Downtown Code Design Review Committee

Meeting Minutes

February 13, 2020

1) Nashville Yards District Signage

Figure 3: Street Facing and Non-Street Facing Activated Facades with Pedestrian Paths

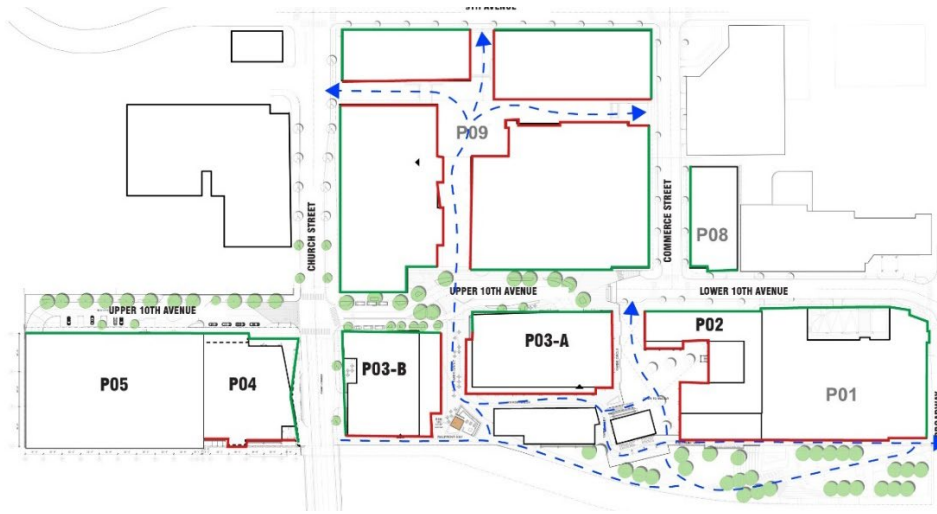
In addition to activating façades that face streets, Nashville Yards activates the pedestrian paseo that flows through the site with pedestrian-only space lined with active uses. Figure 3 below shows this condition, with activated non-street facing façades shown in red and internal pedestrian flow shown in blue. Several non-street-facing façades within Nashville Yards feature two levels of activated space facing walkways or other pedestrian spaces, which essentially doubles the signage on a façade that is allocated half of the typical entitlement for façades facing streets.

Figure 6: Digital Signage on Parcel 1 (left), Location of Digital Signage on Parcel 3 (right)

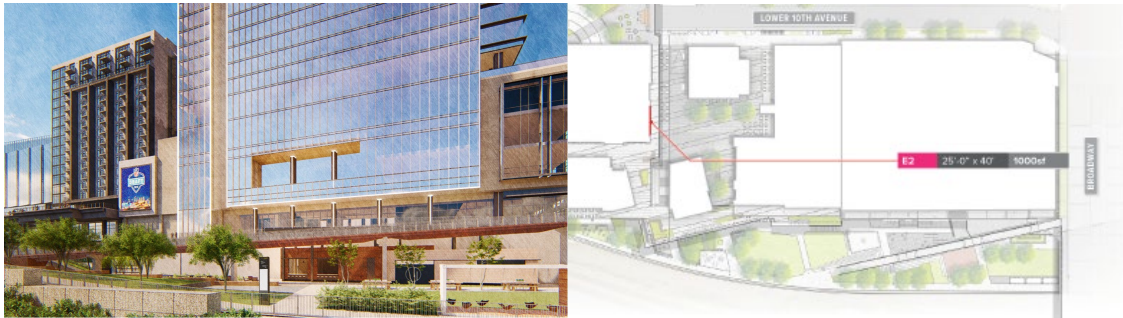
Digital signs on Parcel 1 and Parcel 3 face gathering spaces that are internal to the property. The sign on Parcel 1 faces the Nashville Yards open space and is integrated into the structure of the building. The digital sign is nearly 300 feet back from Broadway and is oriented towards the gathering space and not the street. The sign on Parcel 3, as shown in Figure 6, is internally focused and positioned above the heart of the pedestrian walkway system.

1. Skyline signs affixed to the conceptual tower on Parcel 3a and both conceptual towers on the western portion of Parcel 9 shall conform to the sign area allowed for each building's final height.
2. Modifications approved to allow digital signage shall terminate if the subject sign is moved from the placement specified by this common sign package.
3. All other standards associated with the use of digital signs, including brightness and duration must be followed.

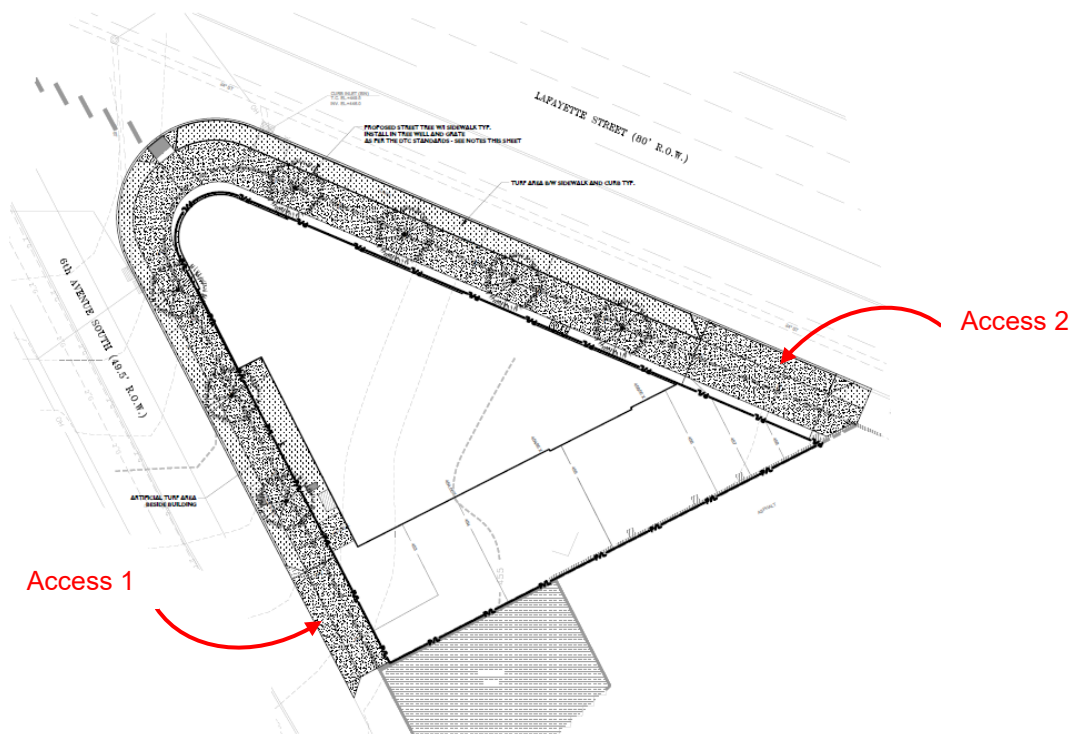
- Required: An active ground floor use requirement shall mean a habitable space occupied by retail, office, residential, institutional or recreational uses, specifically excluding parking and mechanical uses.
- Proposed: The applicant is requesting the DRC limit parking exclusion of active use to automobile parking.

- Required: Access from public streets shall be considered in the following order: Other Streets, Secondary Streets, Neighborhood Streets, and then Primary Streets as approved by Metro departments. Lafayette Street is a primary street and 6th Avenue is a secondary street. Staff recommends access to occur from 6th Avenue, and not Lafayette Street. Reviewers shall consider the public safety, street character, and pedestrian experience.
- Proposed: Access points are proposed on 6th Avenue South and Lafayette Street.

Lafayette Street Elevation

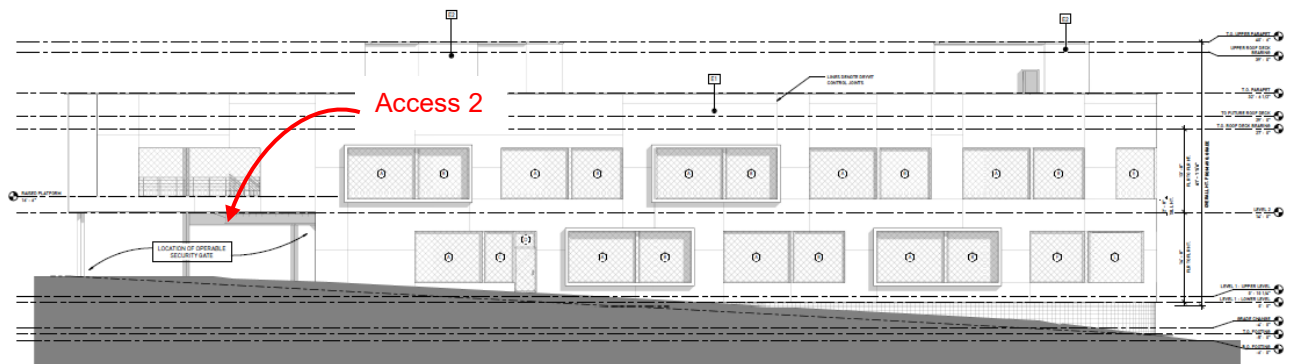
A ground floor active use is required of any project within the DTC and Planning staff has several concerns with the request to permit a non-active use. First, the proposed amount of non-active use is a significant portion of the building. The diagram below illustrates the area of frontage with a non-active use e.g. the parking, maintenance, storage, and rental of pedal vehicles. Approximately 70% of the frontage along Lafayette Street and 100% of the frontage along 6th Avenue South contain no active ground floor use.

The Downtown Code emphasizes the need to mitigate conflicts between pedestrians and vehicular traffic by reducing the number of curb cuts where possible and encourages access points to not occur along primary streets (Lafayette).

1. Continue to work with Planning staff on a building design that considers the following:
 - Framing the corner intersection in a manner that is pedestrian-friendly by means of pedestrian entrance, window openings, or use of architectural features.
 - Using durable, high-quality finish materials, such as brick, brick veneer, fiber cement board, and metal panel systems.
2. Remove access point along Lafayette Street.
3. Sidewalk corridor shall be designed with street trees in tree grates versus a planting strip.

First Floor Plan

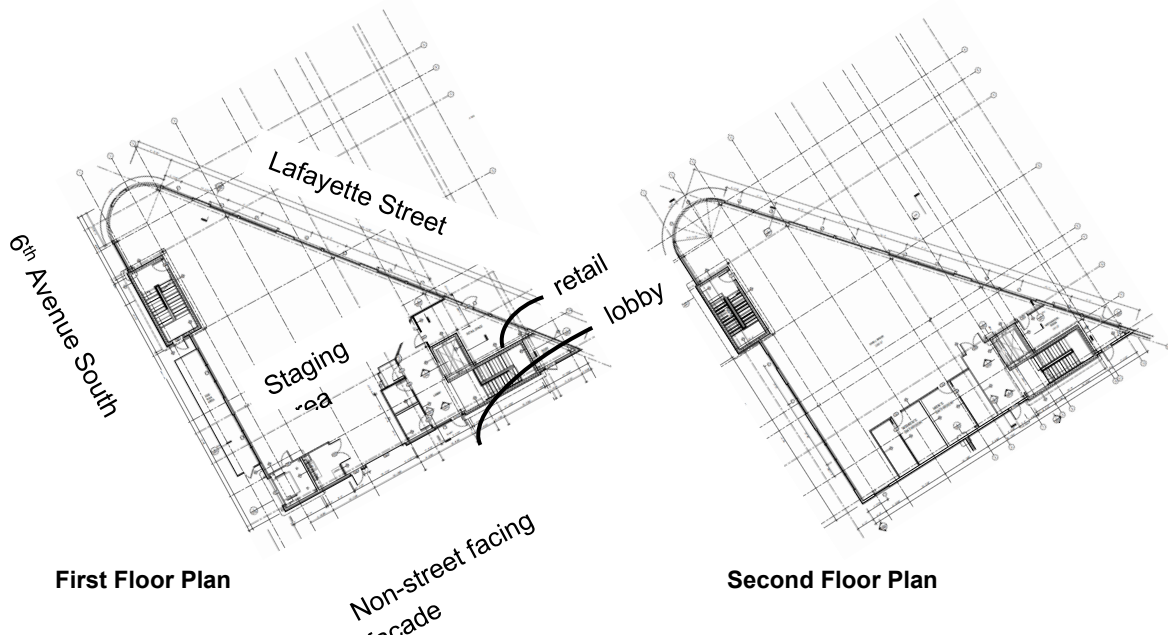
Until a design is submitted that demonstrates a thoughtful and/or exceptional effort to exceed the goals and objectives of DTC, Planning staff finds it unreasonable to recommend approval of the submitted plans at this time.
